Request on road safety grounds for improved signage for Bridleways 24 & 29

The Parish Council is concerned about the safety of pedestrians and cyclists on the busy main approach road into Waldringfield stretching from from Waldringfield Heath into the village [specifically - Ipswich Rd from the Newbourne Rd crossroads (upwardly.hesitate,precautions) to the junction with School Rd/Fishpond R (sinkhole.certainty.climber).]

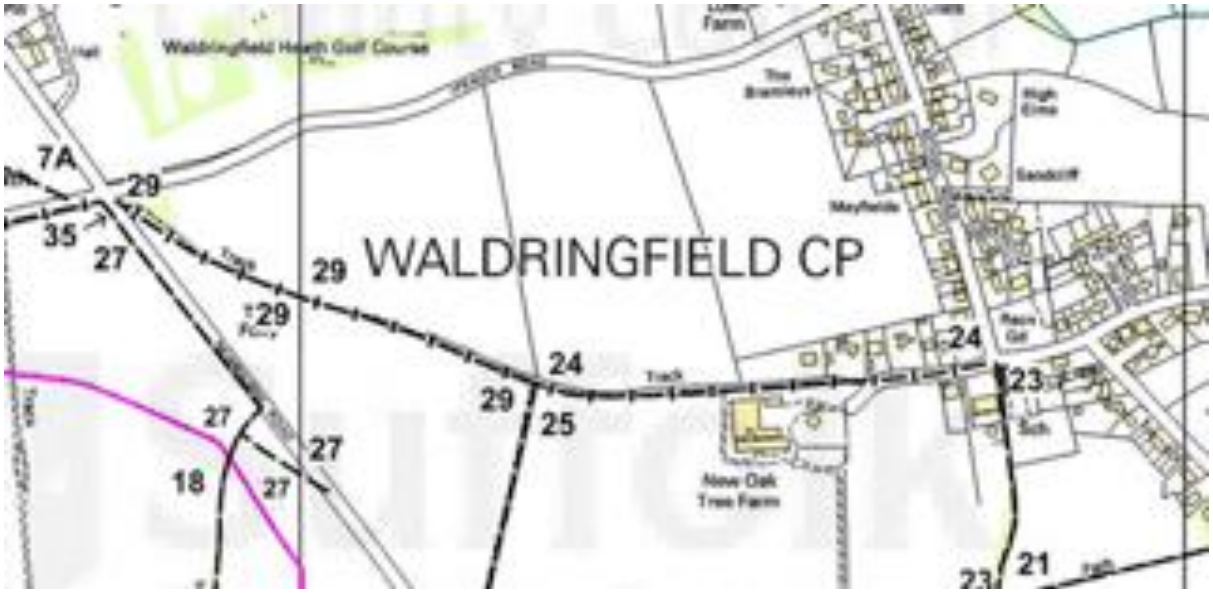
Sign at Waldringfield Heath to be replaced by one indicating “To Waldringfield”

Sign at entrance to School Lane in Waldringfield. Fingerpost to be moved to more prominent position two metres away from hedge with new bridleway sign stating “Towards Brightwell Lakes and Martlesham”. The sign on the post for Footpath 23 to be retained.

Where the bridleway (to the right) diverges from the farm lane. A bridleway confirmation sign to be installed here.

The plethora of signs at Waldringfield Heath. The footpath post is rotten and collapsing. It should be replaced with an additional finger pointing south east across the road stating “Bridleway towards Waldringfield”.
